### 国際予備審査報告

| 出願人又は代理人<br>の書類記号 NEC-1519PCT                | 今後の手続きについては、国際予備審査報告の送付通知(様式PCT/<br>IPEA/41.6)を参照すること。   |
|--|--|
| 国際出願番号<br>PCT/JP03/08557                     | 国際出願日<br>(日.月.年) 04.07.2003 優先日<br>(日.月.年) 16.07.2002  |

Translation of Amendment filed December 19, 2003

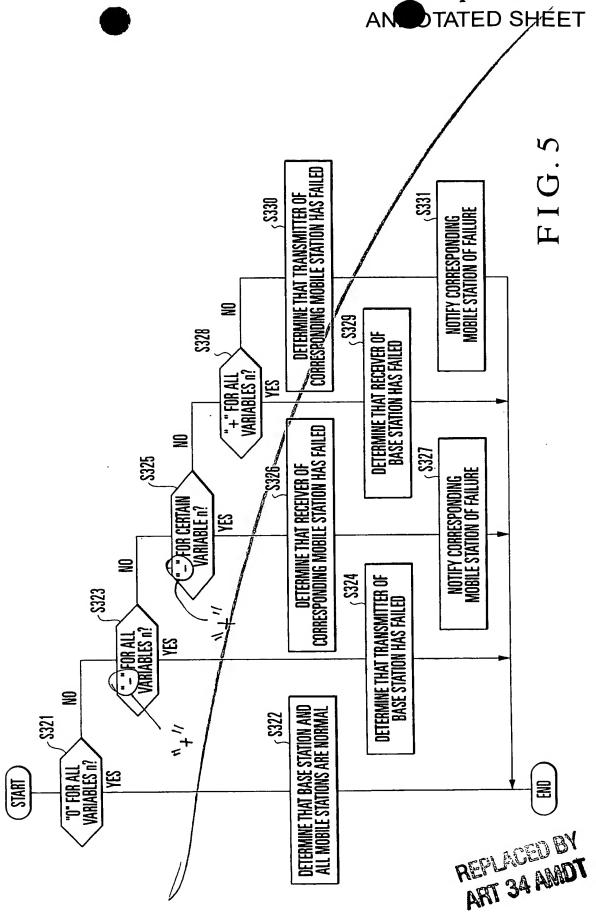
- 5. Contents of Amendment
- (1) Pages 22 to 23 of the specification: Amend "+" to ----, and "-" to --+--.
- (2) Claims, Pages 32 to 33, claims 5 and 6: Amend "receiver" to --transmitter--, and "transmitter" to --receiver--.
- (3) Drawings, Page 5/6, steps S323 and S325 in Fig. 5: Amend "+" to ----, and "-" to --+-.
- 6. List of Documents Attached
  - (1) Specification, Pages 22 to 23
  - (2) Claims, Pages 32 to 33
  - (3) Drawings, Page 5/6
